Rolleston Pak'nSave Resource Consent Application

Transport RFI Response

Prepared for	Foodstuffs South Island Limited
Job Number	FSIL-J085
Revision	FINAL
Issue Date	18 February 2022
Prepared by	Jay Baththana, Principal Transportation Engineer
Reviewed by	Dave Smith, Technical Director

Figure 1 Sketch of Levi Road/ Lincoln Rolleston Road upgrade

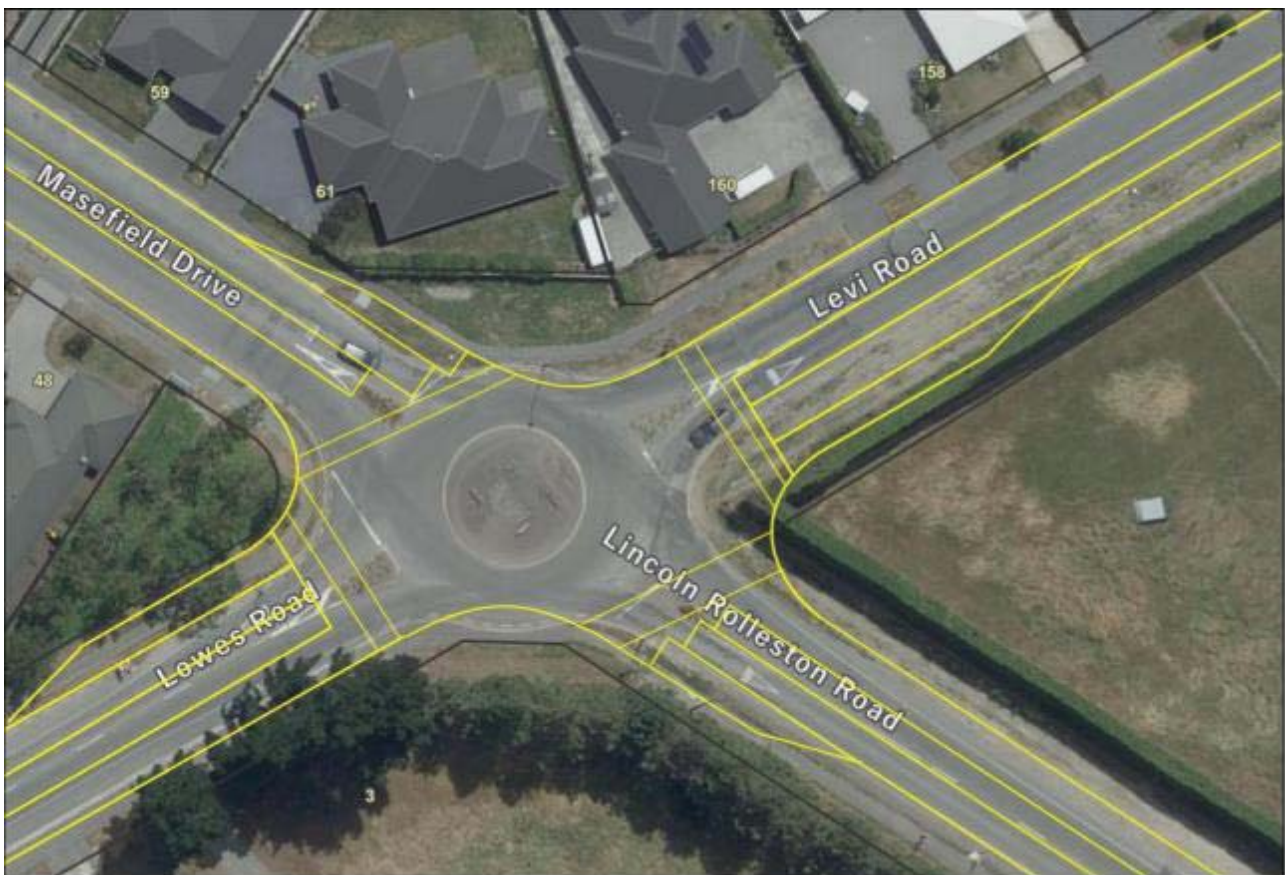
Figure 7.3 shows an indicative layout for a scheme at the Levi Road / Lowes Road intersection. This layout has no clearance between the proposed kerblines and the northwestern corner of the site and so a footpath could not be provided within the road reserve here. It also shows a wide crossing on the southern approach, likely to be associated with a shared walking/cycling route, but the report states that the shared route should be on the north of Levi Road (not the

south). It also appears that the indicated left-turn lane on Lowes Road means that the existing footpath would need to be removed, as the extent of land remaining between the kerblines and the road boundary is too narrow. While it is appreciated that it is a sketch design, it appears that this layout is at odds with statements made in the report.

7. Please can the layout (or the report) be updated so that they are consistent with one another. This issue is particularly relevant for the number of approach lanes, as if the three lanes currently assumed have to be decreased to two lanes, then the capacity of the intersection will change.

The sketch in the ITA (shown below) was prepared assuming the shared path along Levi Road would be on the south side of the road. However, the shared path location is not finalised. The sketch shows that if a shared path or a footpath is to be located on the south side of Levi Road, a slither of land from the supermarket site would be required at the northwest corner of the site to accommodate this. The client is aware of this issue and would be willing to work with Council to address the matter.

At the Northwest corner of the intersection, it is assumed that the reserve (triangular section of land) owned by Council could provide a footpath/ pedestrian path within it which would allow the sketched number of lanes to be provided. It is further noted that the modelling results show that the supermarket is not reliant on the intersection upgrade.

Figure 2 Delivery vehicle access restrictions

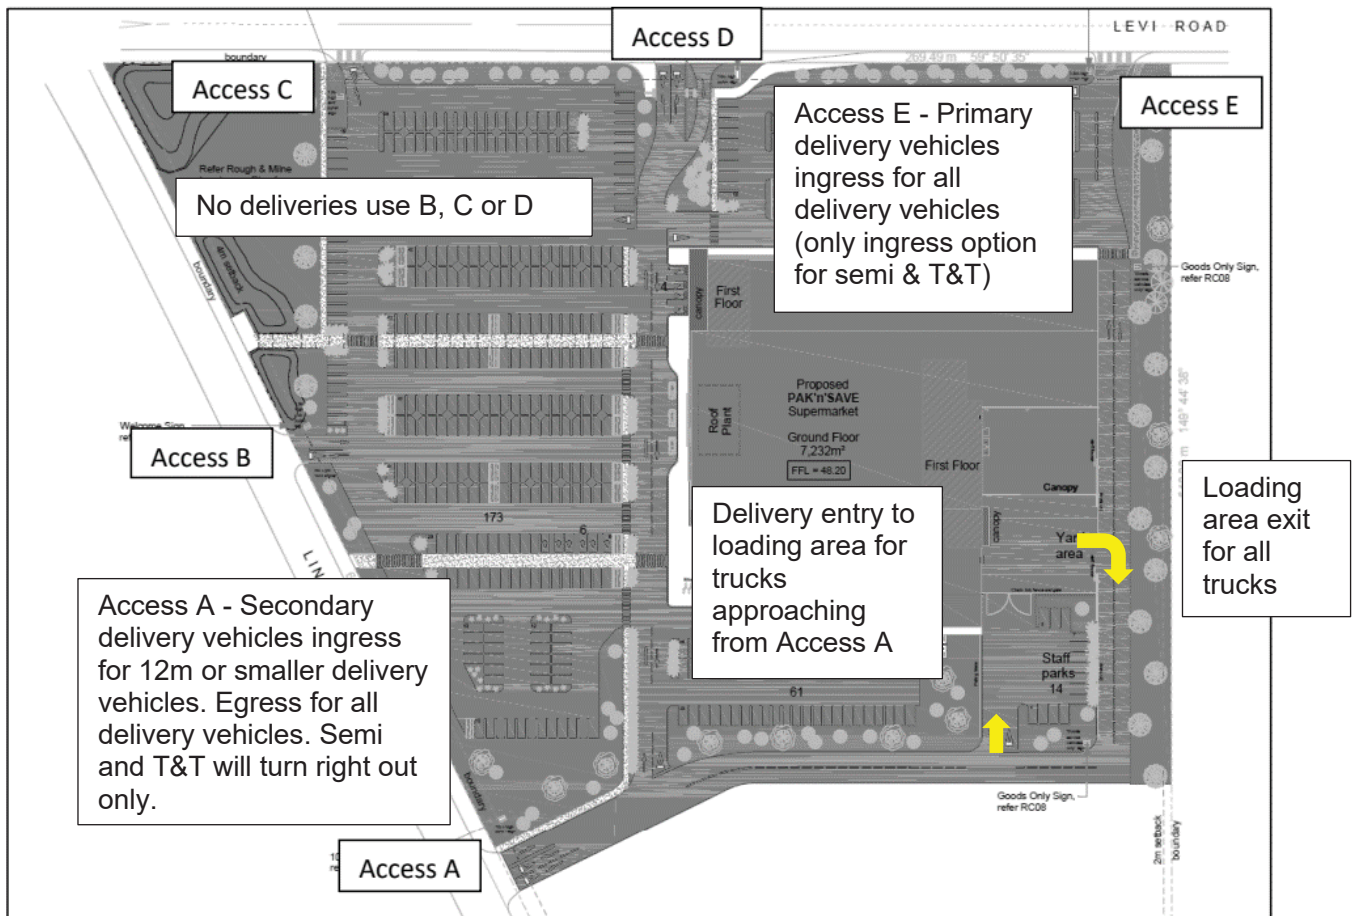
The swept path for a semitrailer (at the south-eastern corner) shows it over-running outside the proposed service lane (on the inside radius) and crossing well over the centreline of the service lane.

24. Please advise whether any design changes are proposed in this location, and comment on whether overrunning in this manner will lead to adverse road safety effects.

The semi-trailer trucks are anticipated to track across the width of the service lane (southeast corner) when turning however give the frequency of visits, provided visibility, travel speeds and restricted access at this location no adverse safety effects are anticipated. The figure below shows the anticipated truck movements within the site. No conflict is anticipated at the south-eastern corner as all vehicles will be travelling in the same direction.

Furthermore, the south-eastern corner is proposed to be kept clear of vegetation and the 2m fence will be permeable to allow for sufficient visibility.

All delivery and service vehicles arriving from the west are expected to use the staff car park entrance to enter the Yard Area as shown below. The staff car park has very limited parking turnover during the day when most of the 12m truck deliveries are anticipated. Even then not all deliveries are expected to arrive from Access A. Deliveries coming from Christchurch are more likely to use Access E to enter the site. Based on these reasons the slight overrun at the staff car park entry is not anticipated to compromise safety at the site. Appropriate signage and line marking will be used to ensure safe operation.

Figure 3 Available visibility at Access D

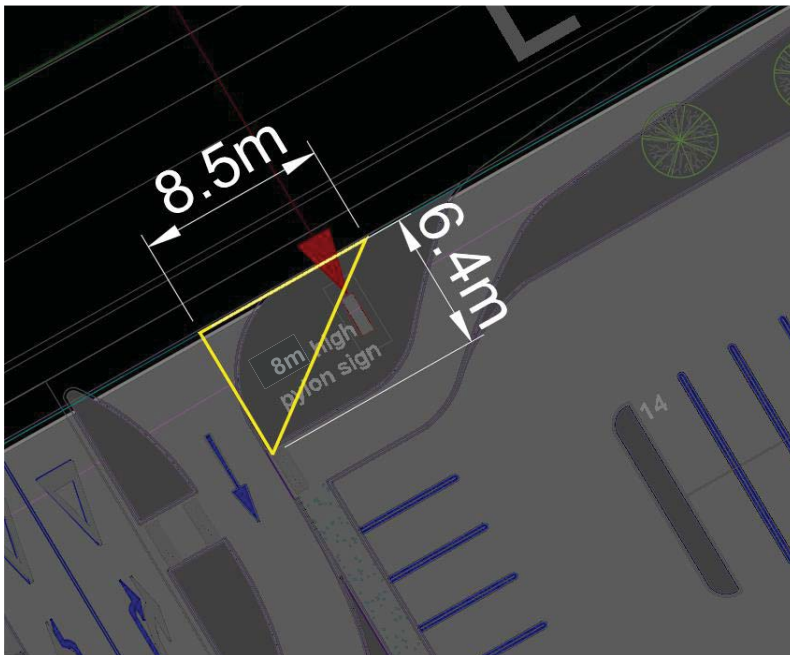
There appears to be signage to the immediate east of Access D.

26. Please confirm that this does not adversely affect sight distances.

The pylon sign is located 12m from the exit lane well outside the typical 5m x 2m visibility splay. For incoming vehicles a visibility splay of 8.5m by 6.4m is available which is adequate to provide sufficient intervisibility between left turning traffic and pedestrians crossing the access. Based on the available intervisibility no adverse effects on pedestrian safety is anticipated.

Figure 4 Site layout changes

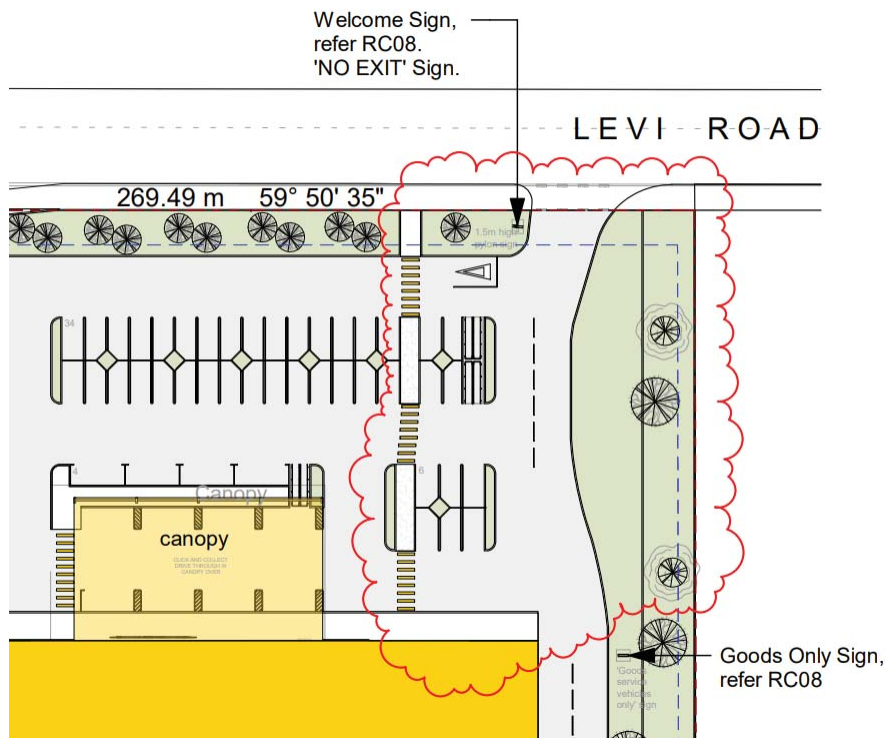
It is noted that the pedestrian entry close to the north-east boundary has not been identified as a pedestrian route (figure 11, page 21). Please provide further information

The reviewer mentioned pedestrian connection has been relocated from the eastern boundary by removing four car parking spaces as shown below. This removes potential pedestrian & delivery vehicle conflict at the corner of the building whilst also connecting the northeast car park to the supermarket better. The removal of four parking spaces is inconsequential given the ample capacity of the car park.

Figure 5 Pedestrian connections

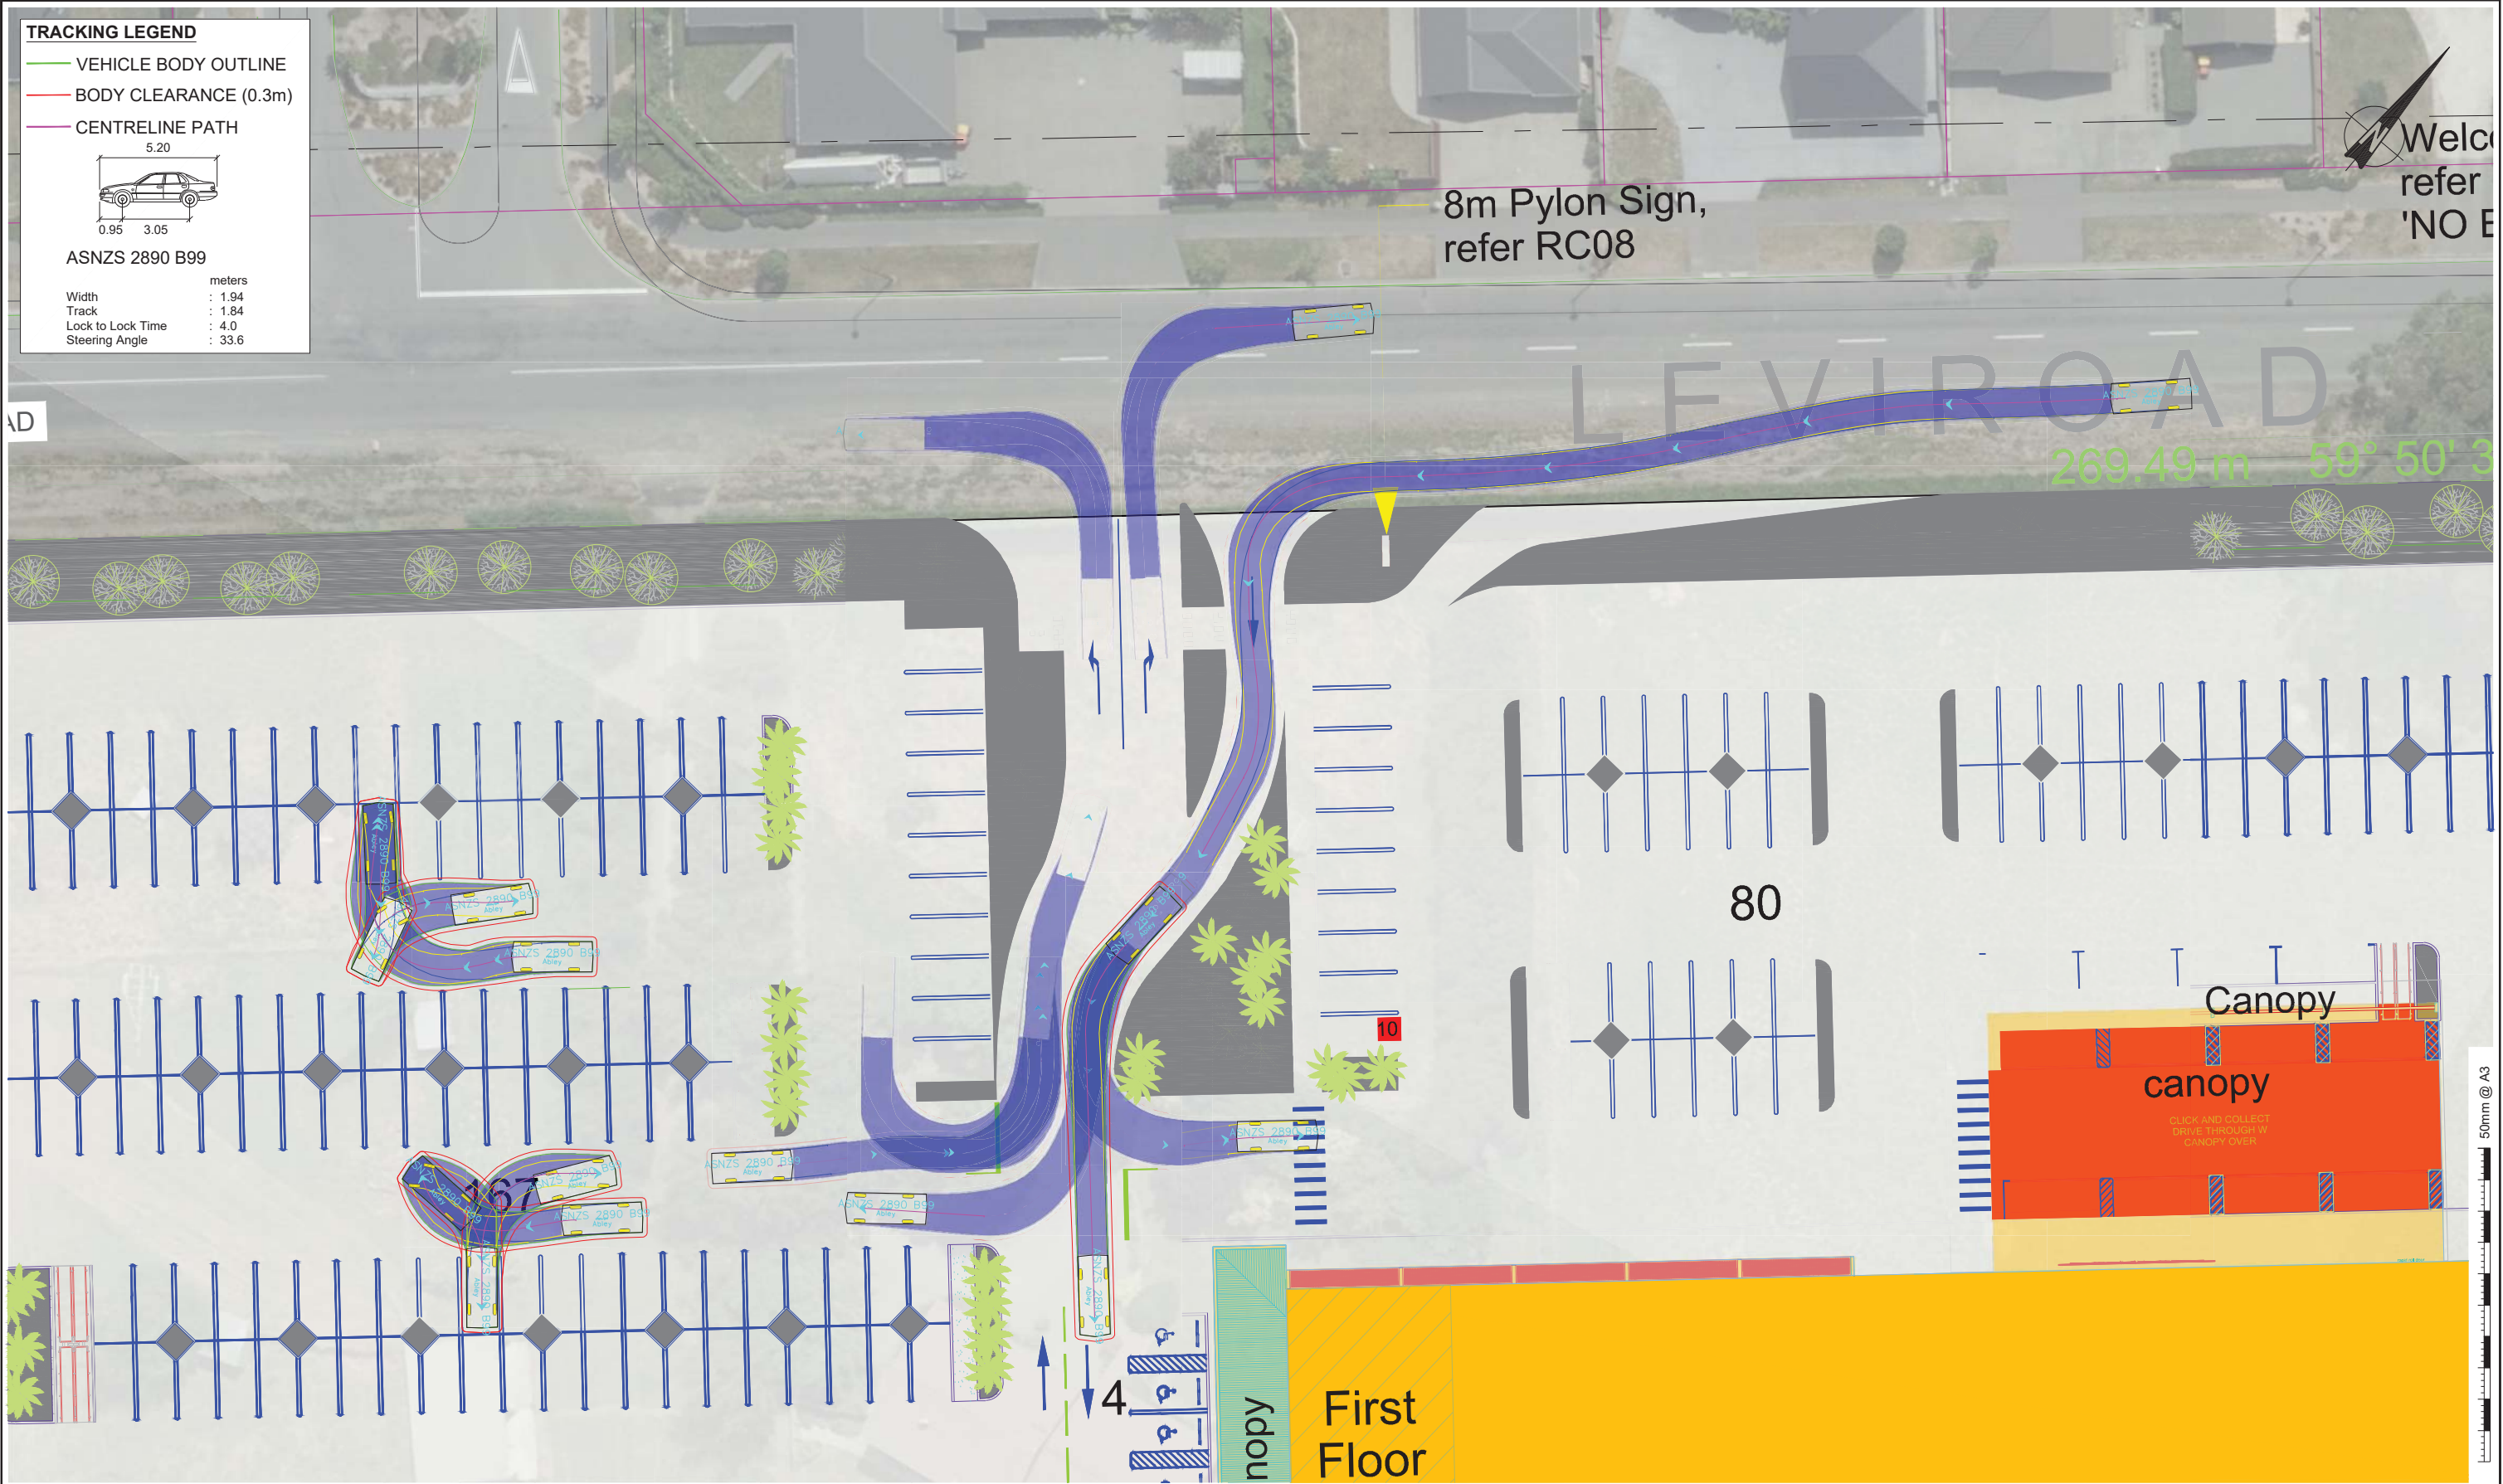
Please advise whether pedestrian routes have been aligned with desire lines.

Please confirm hierarchy of pedestrian routes within car park (as mentioned on page 24). Please confirm how safety in public spaces is addressed?

As shown in the figure below, the internal pedestrian paths link well with existing/ future frontage road footpaths. More importantly, they will align with pedestrian desire lines approaching the supermarket from all directions. Customers walking from nearby residential areas will have multiple pedestrian access points to access the supermarket which follow dedicated internal pedestrian paths to the main entrance. Most pedestrians will not need to cross the main vehicle accesses (Access A and Access D) to access the supermarket, which is a highlight of the proposed layout.

The internal pedestrian paths shown in the figure below will be at a similar hierarchy. The network of paths provides good connectivity from all parking spaces to the main building.

The supermarket car park will be sign posted with a 15km/h speed limit to ensure customers are aware of the change in speed environment. The placement of mobility parking, two pedestrian crossings and the taxi stand along the main aisle naturally creates side friction (traffic calming) along the longest aisle of the site. The car park will be well lit, sign posted, and line marking will be used to clearly define priority at pedestrian crossings and at aisle intersections. Further details will be provided at detailed design stage.
